service bulletin

No. 92-10

STA-STRAP and LINK ROD INTERFERENCE - 75 THRU 115

75 thru 115

Figure 1. Incorrect Sta-Strap Position

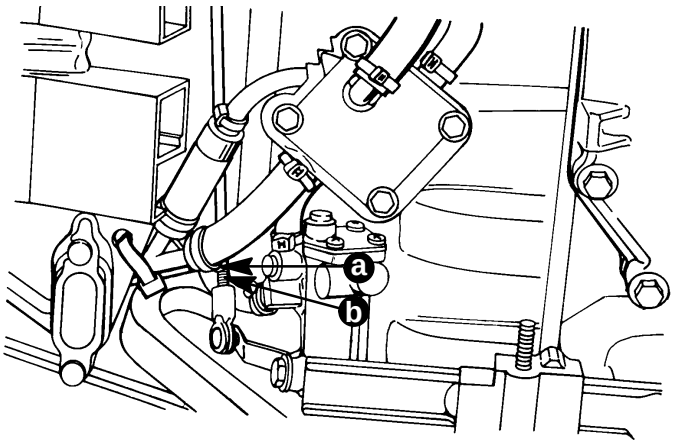
The models listed may have a fuel line sta-strap installed in a position which allows the locking tab to contact the oil pump link rod. If sufficient contact occurs, the carburetor throttle plates may not be allowed to return to the closed position and results in a higher than desired idle speed. The locking tab of the fuel line sta-strap must be positioned away from the oil pump link rod to avoid contact.

Inspect outboards listed for sta-strap and oil pump link rod interference. Correct by repositioning the existing sta-strap or by installing a new sta-strap with the locking tab away from the link rod.
